Addendum No. 2 February 21, 2022

Twin Falls Fire Station 2

This addendum addresses the following:

The following are changes, deletions, corrections, additions, and/or modifications to the drawings, specifications, contract conditions, and bidding documents dated **January 18, 2022**. Bidding parties are required to acknowledge receipt of this addendum on the bid form. Failure to do so may subject the bidder to disqualification.

Sheet No:
G0.05

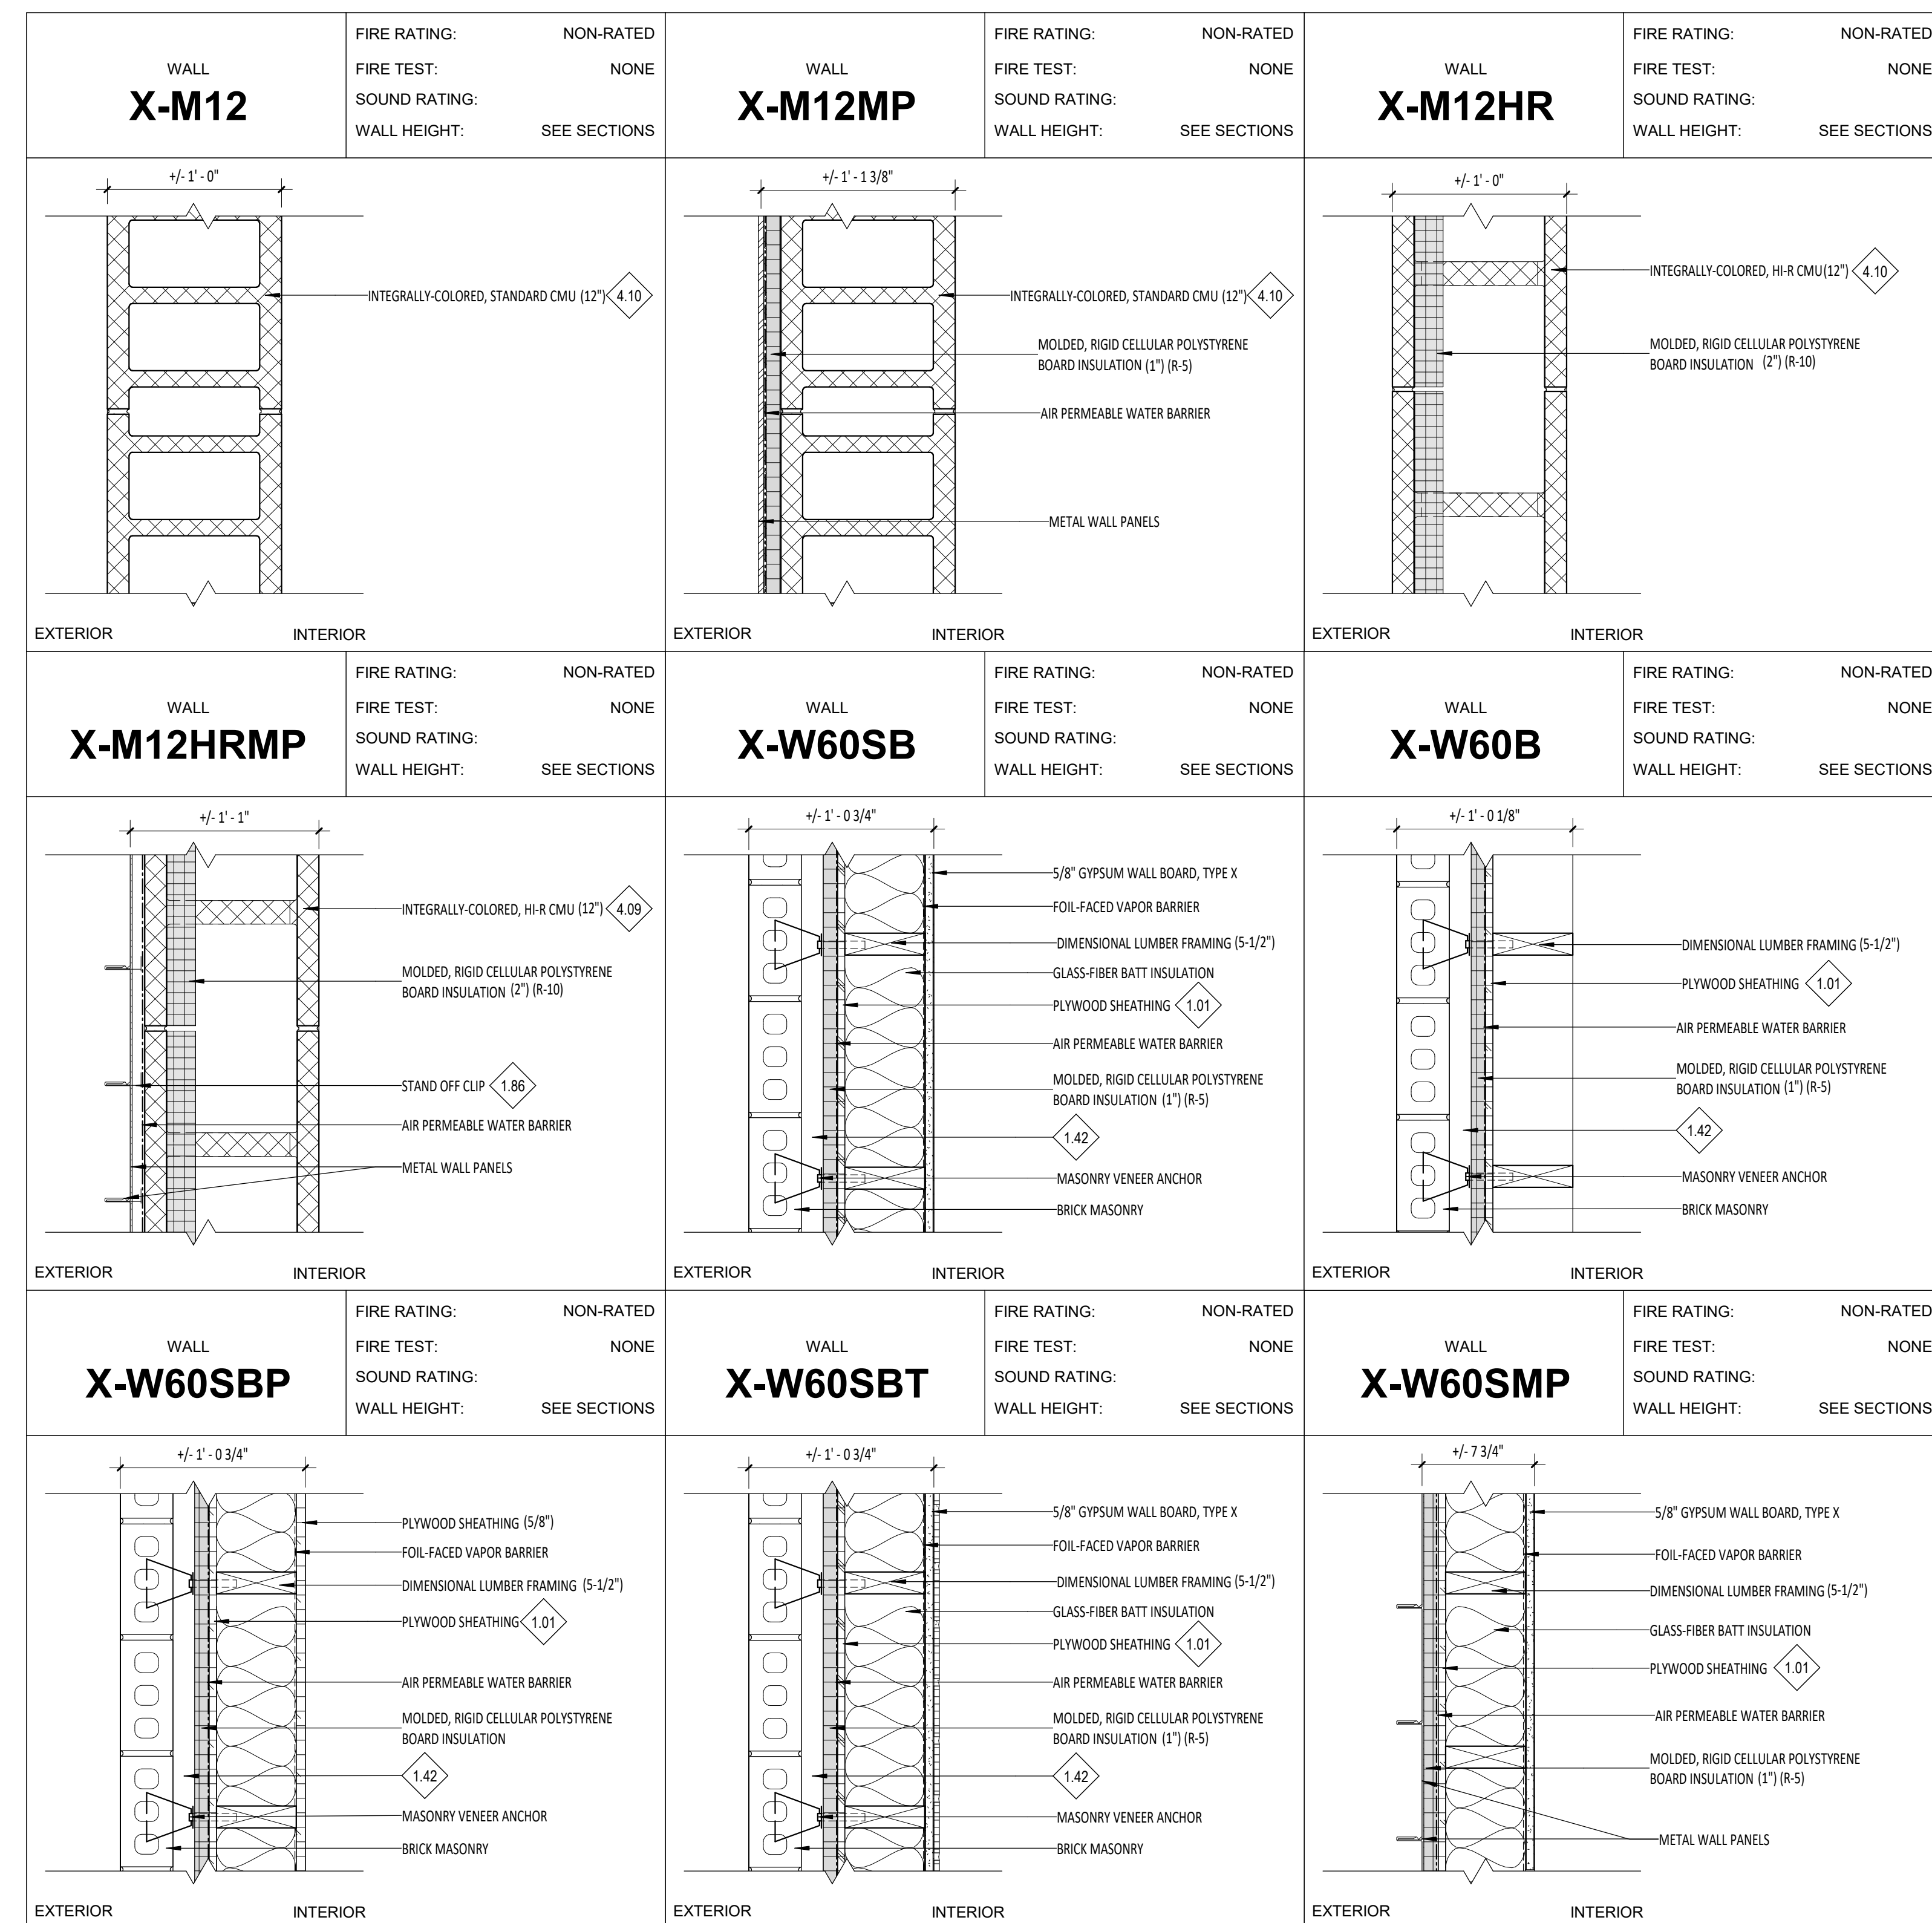
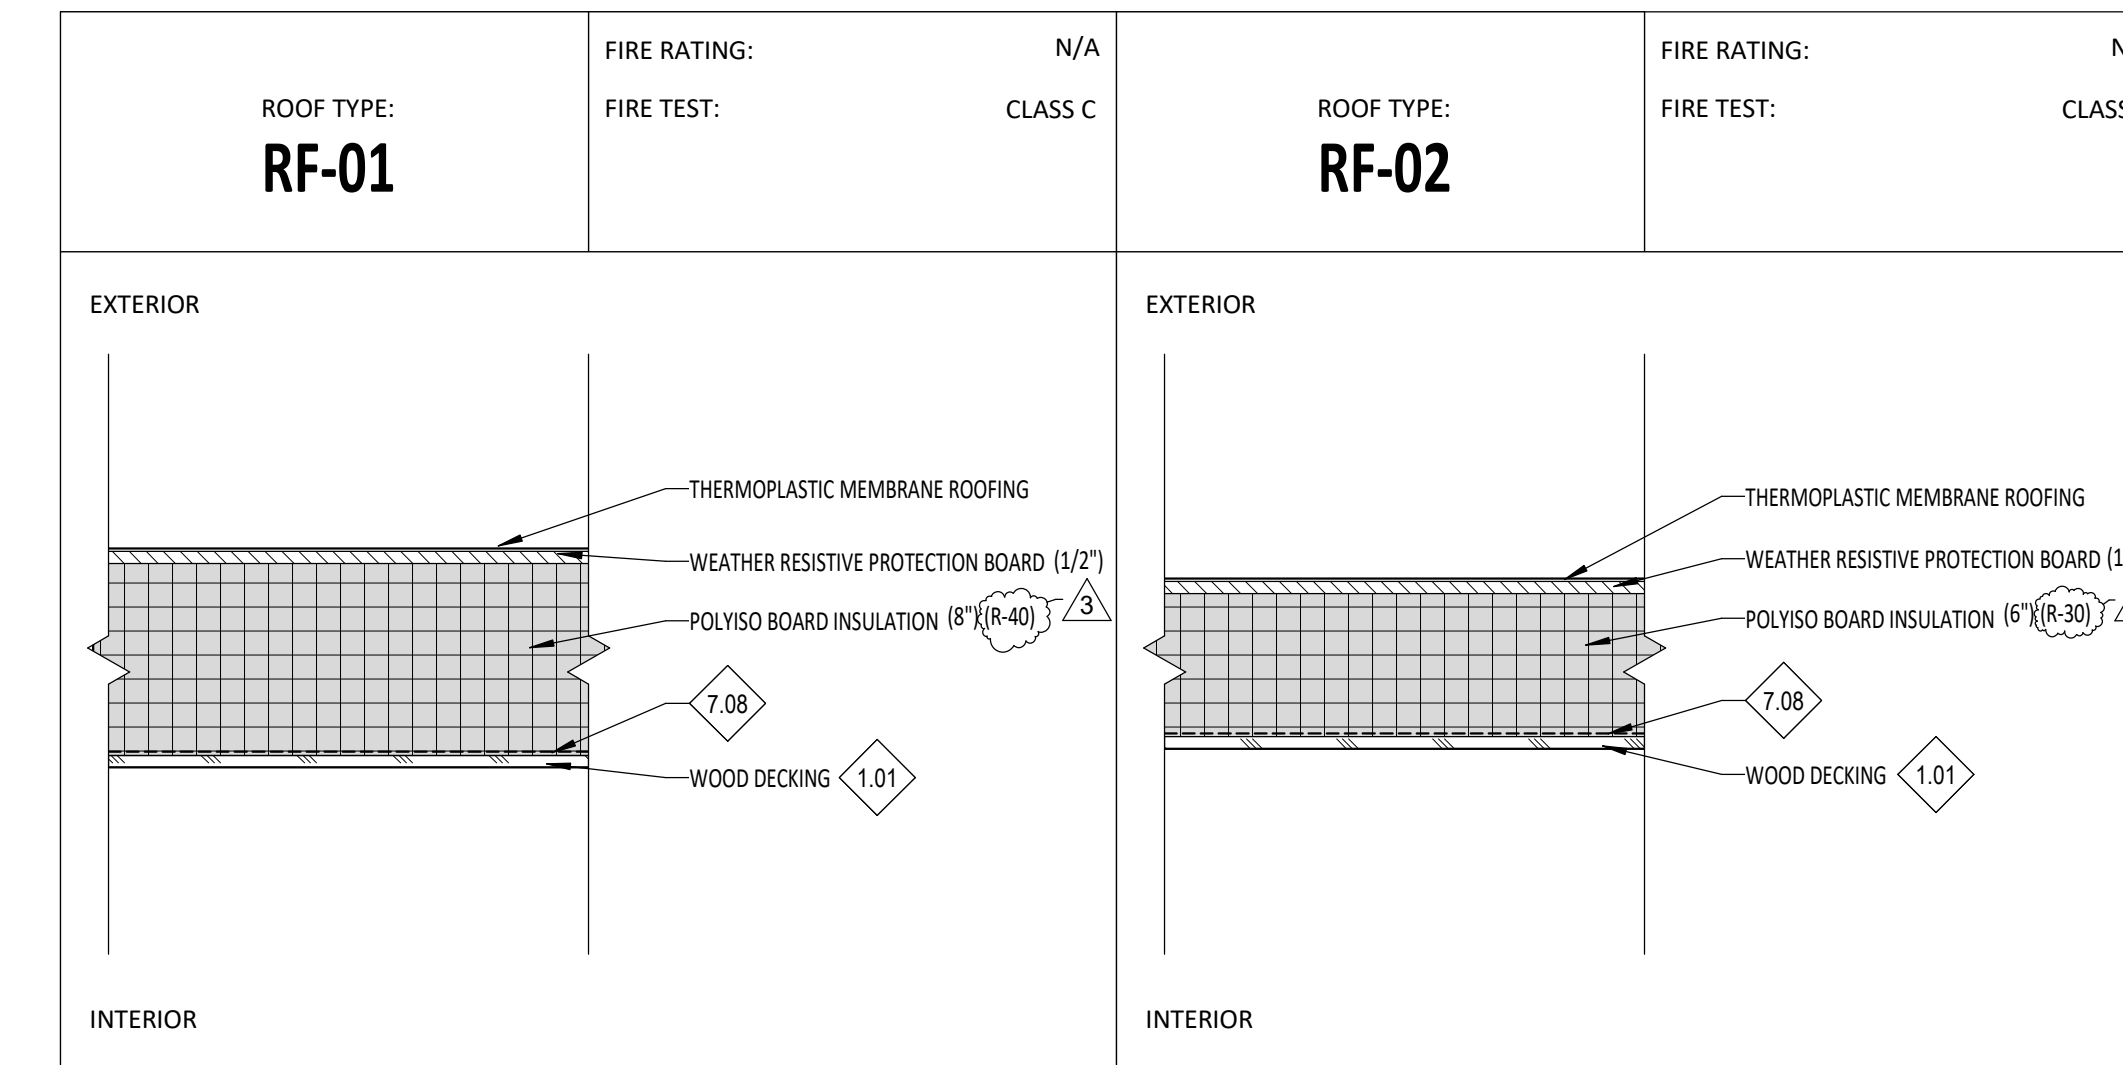
1. Sheet G0.02 DRAWING INFORMATION
 - a. ADDED keynote 042000.G CONTROL & EXPANSION JOINT
2. Sheet G0.05 WALL TYPES AND RATED ASSEMBLIES
 - a. ADDED R-Values to RF-01 and RF-02
3. Sheet A2.01 LEVEL 1 – COMPOSITE FLOOR PLAN
 - a. ADDED dimension string for door 128a
4. Sheet A2.31 COMPOSITE ROOF PLAN – LOW ROOF
 - a. ADDED roof tags
 - b. REVISED walk pads
5. Sheet A2.32 COMPOSITE ROOF PLAN – HIGH ROOF
 - a. ADDED roof tags
6. Sheet A2.91 ROOF DETAILS
 - a. REVISED Detail C1 TYP ROOF HATCH DETAIL
7. Sheet A3.01 BUILDING ELEVATIONS
 - a. ADDED control joints to Detail E1 EXTERIOR ELEVATION- WEST
 - b. REVISED reference note 4.03
8. Sheet A4.11 EXTERIOR WALL SECTIONS
 - a. REVISED detail E1 WALL SECTION (2 AND 3/I AND H)
9. Sheet A7.91 FRAME DETAILS

E2 ROOF PLAN (LOW)
A2.31 1/8" = 1'-0"

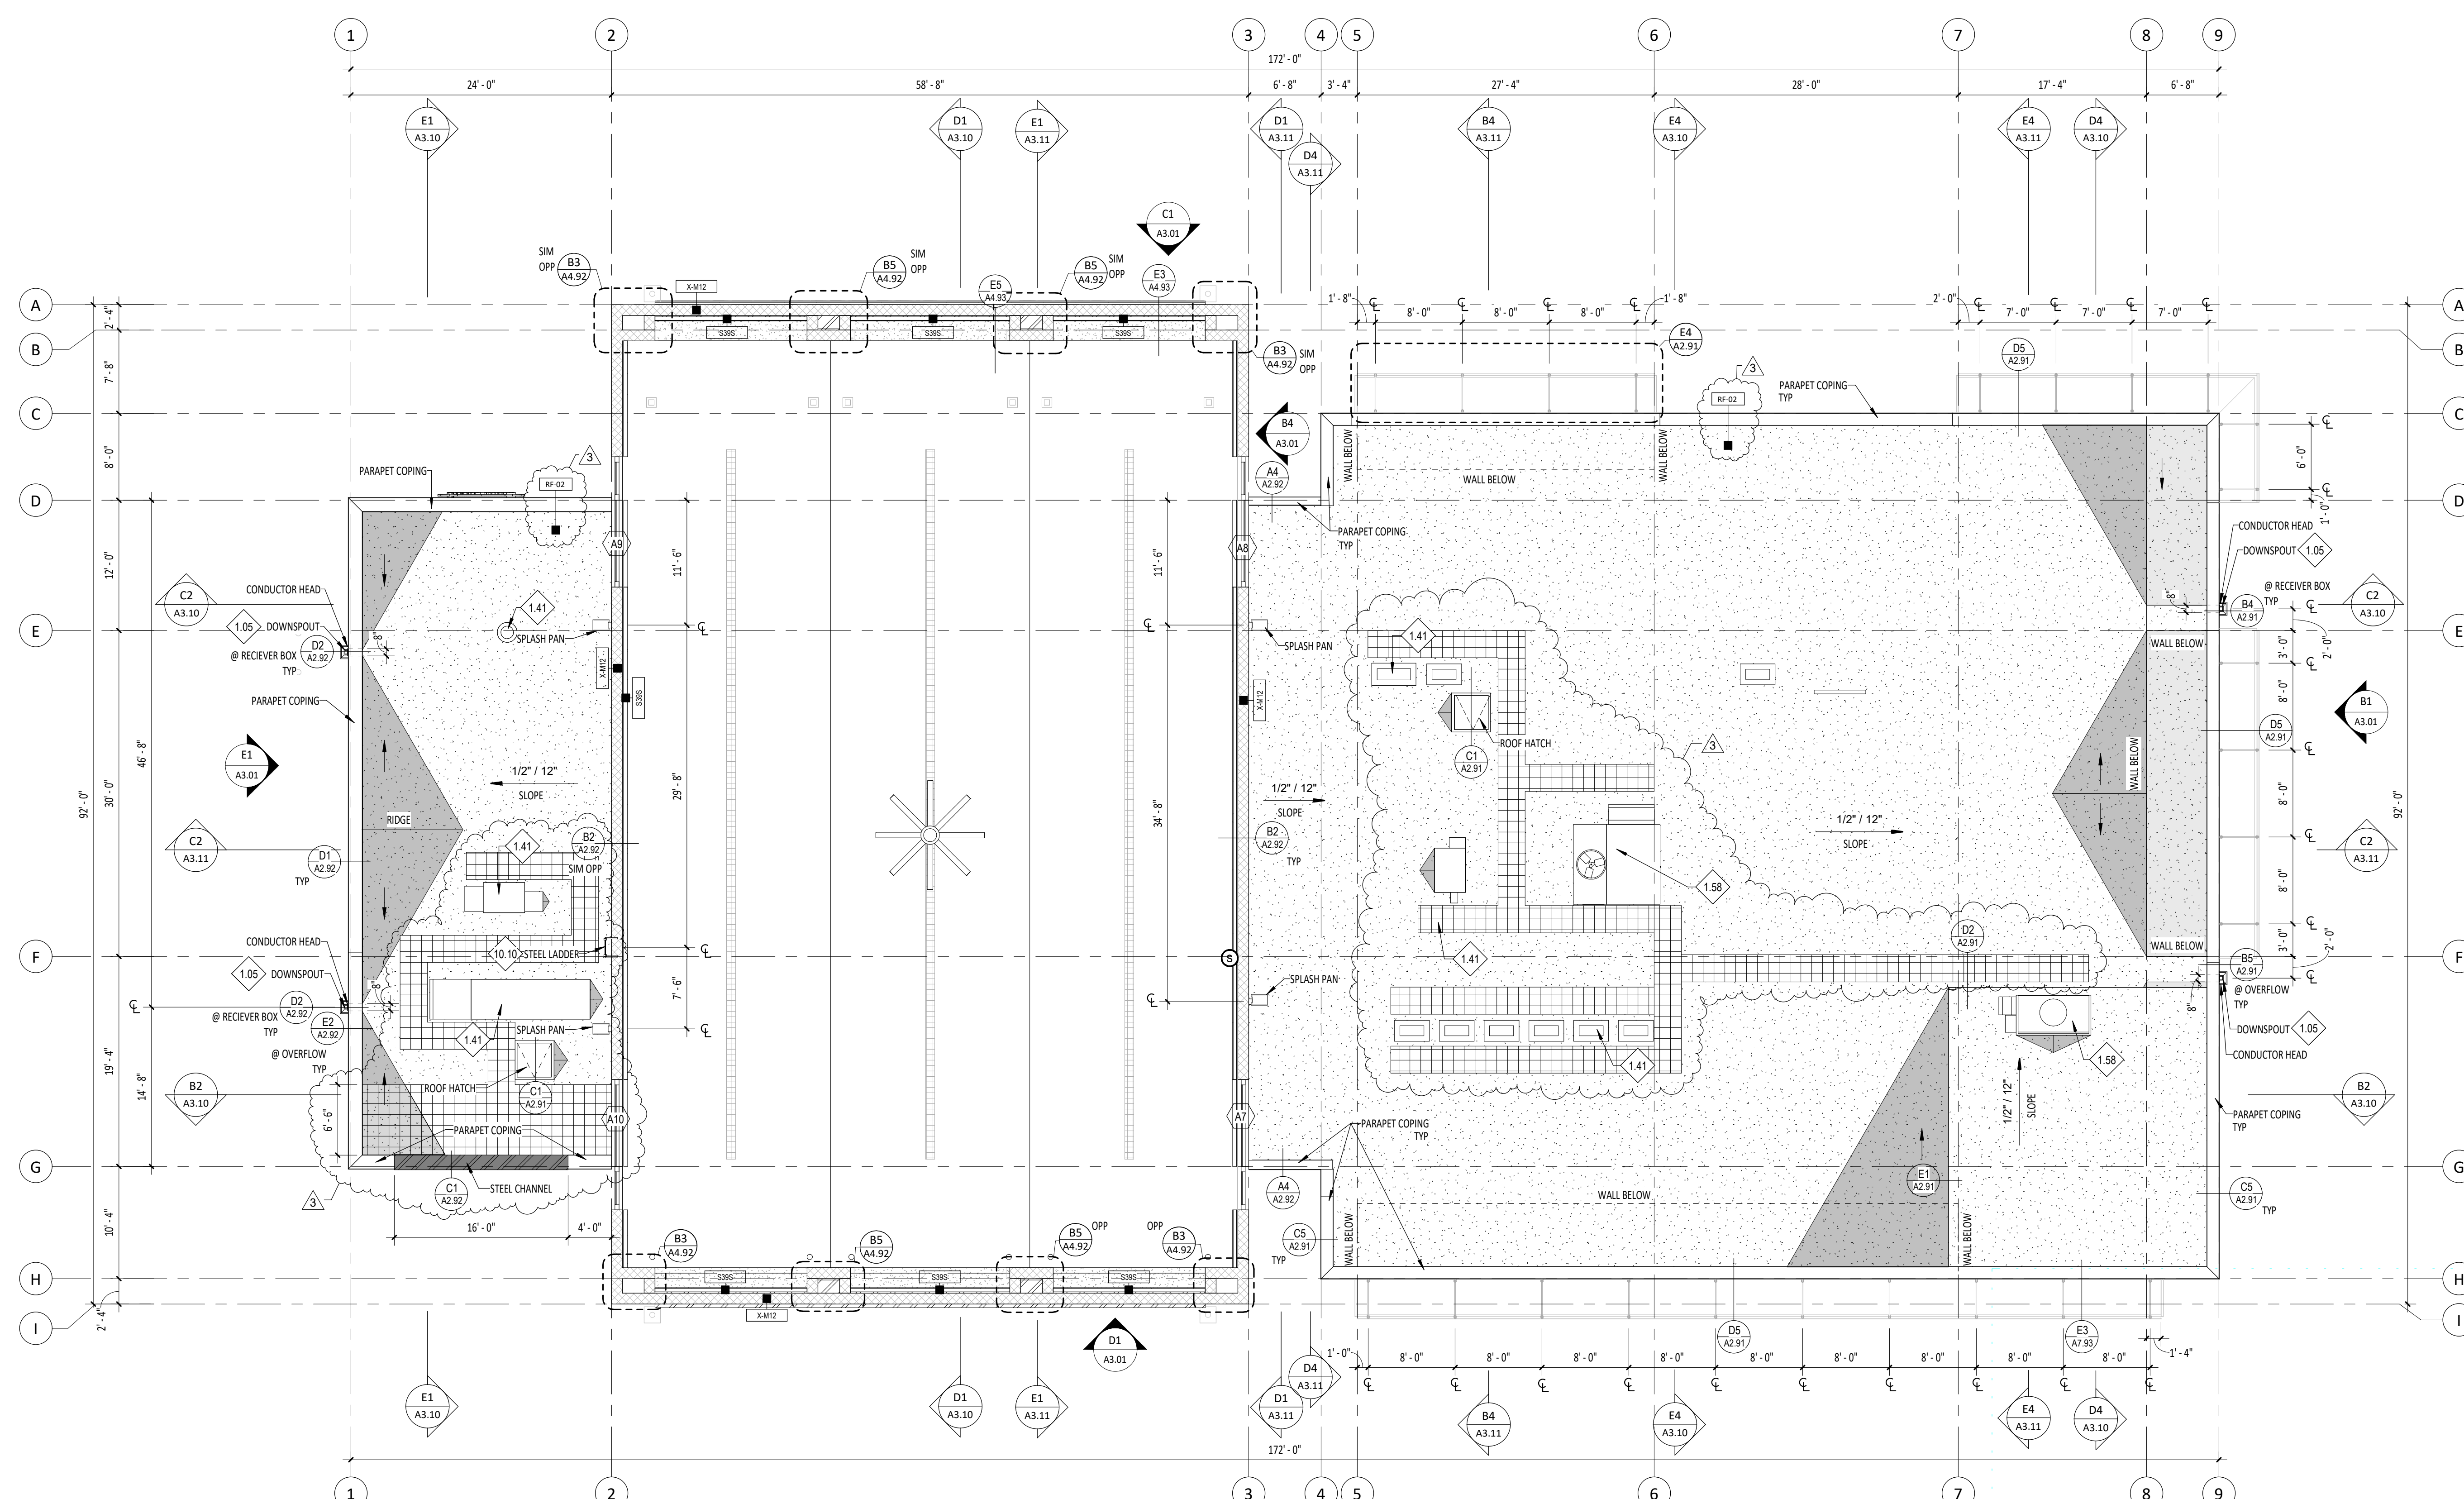
- c. REMOVED South elevation tag in Dayroom 111
- 5. Sheet A2.31 COMPOSITE ROOF PLAN – LOW ROOF
 - a. REVISED dimension string on entry canopy.
 - b. REMOVED Details B3 and D1 / A9.91.
